Project	<b>IEEE 802.16 Broadband Wireless Access Working Group</b> < <a href="http://ieee802.org/16">http://ieee802.org/16</a> >	
Title	MAC Messages supporting the CSI	
Date Submitted	<b>2006-11-16</b>	
Source(s)	Wu Xuyong, Huawei Huawei Industrial Base, Bantian, Longgang, Shenzhen 518129 P.R.C	Voice: +86-755-28972327 Fax: <a href="mailto:wuxuyong@huawei.com">wuxuyong@huawei.com</a>
Re:	80216h-06_059: IEEE 802.16 Working Group Working Group Letter Ballot #24 (2006-10-11)	
Abstract	Discuss the MAC messages supporting the CSI, such as DCD, DL-MAP etc.	
Purpose	To consolidate the working document.	
Notice	This document has been prepared to assist IEEE 802.16. It is offered as a basis for discussion and is not binding on the contributing individual(s) or organization(s). The material in this document is subject to change in form and content after further study. The contributor(s) reserve(s) the right to add, amend or withdraw material contained herein.

## MAC Messages supporting the CSI

*Proposed changes on figure-h14 and h15*

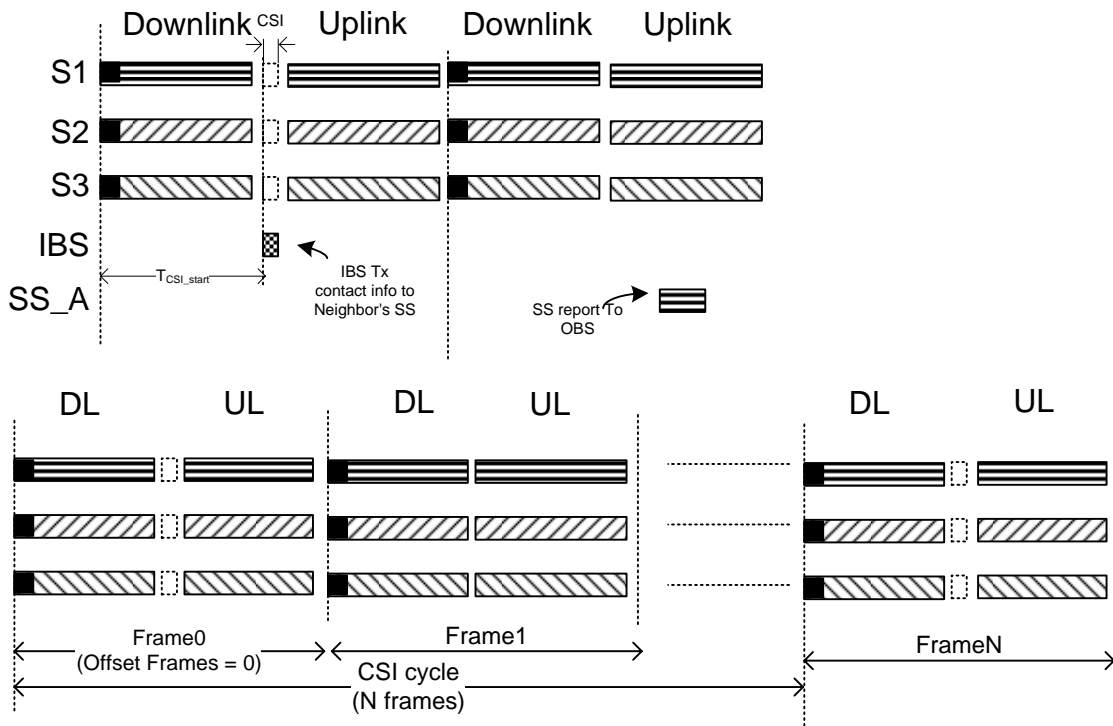
**Proposed changes on figure-h29 and h30**
